# FINAL ENVIRONMENTAL IMPACT STATEMENT

## MIDDLE CREEK WATERSHED

### PENNSYLVANIA

USDA-SCS-EIS-WS-(ADM)-80-1-(F)-PA

MIDDLE CREEK WATERSHED  
BEAVER SPRINGS FLOODWAY PA-639  
SNYDER COUNTY, PENNSYLVANIA  
FLOODWAY - Plan View

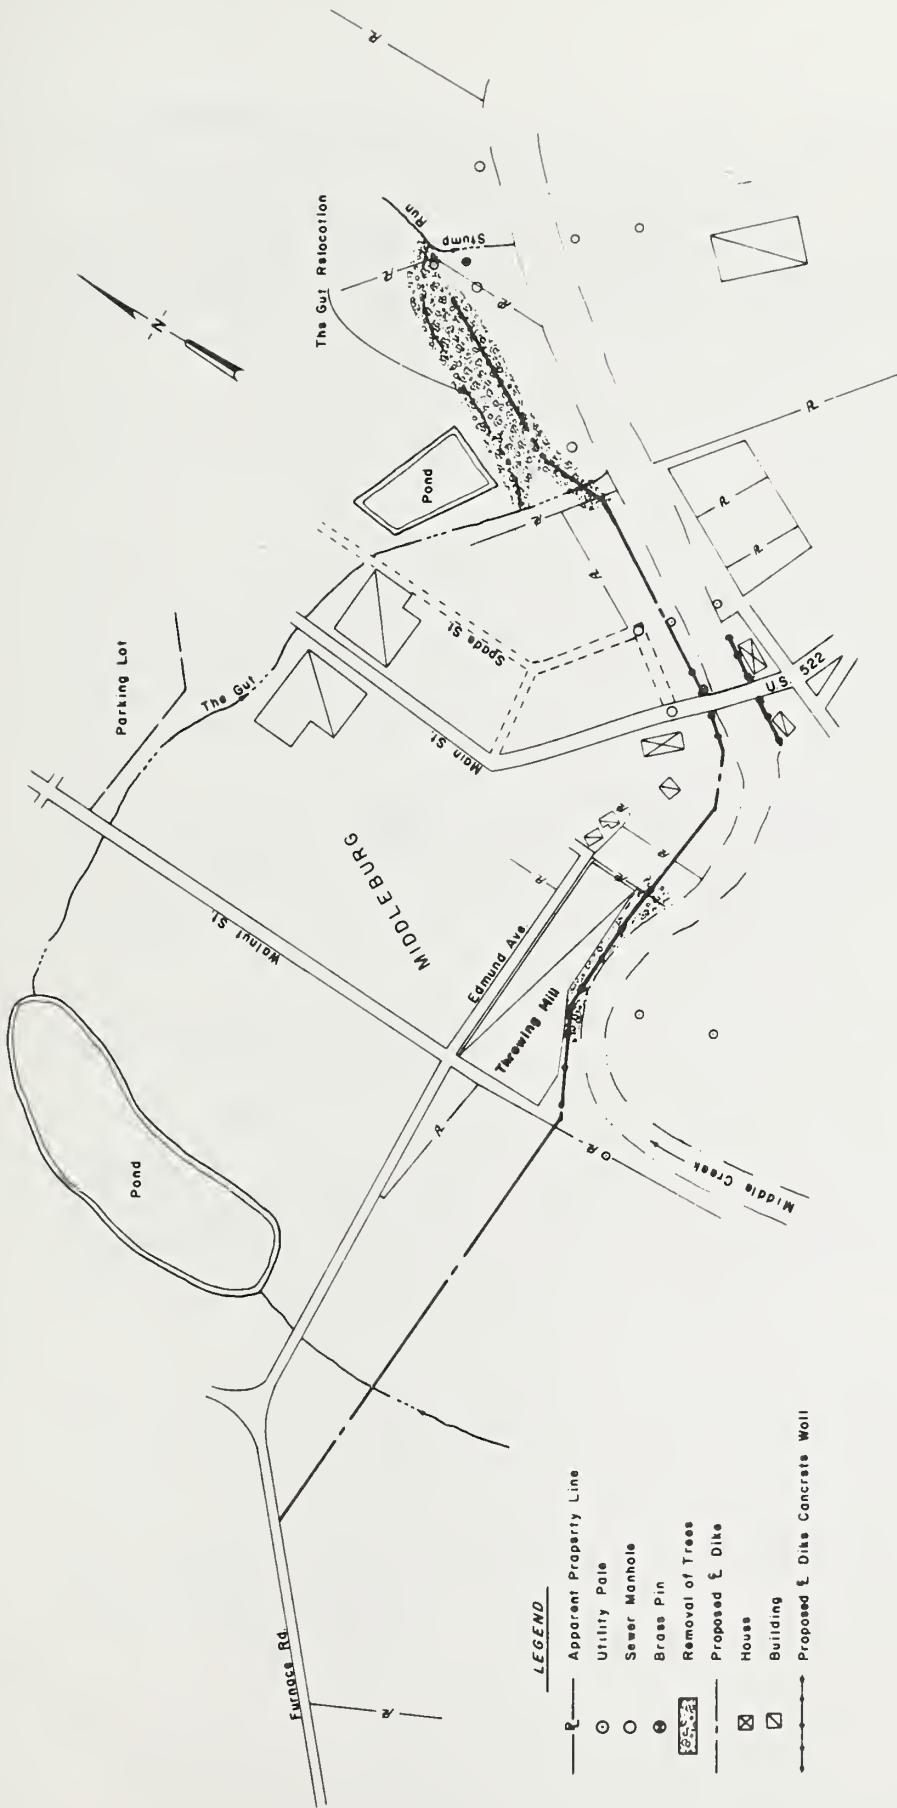
Comment 3: Figure 3 is mislabeled.

Illustrations, Page vii - Figure 3, "PA-639 Location Map" is not at page 7, nor is it elsewhere in the statement. Instead, page 7 shows a "Floodway Plan View," not listed in the table of illustrations. The error should be corrected.

Response: The list of figures has been corrected.
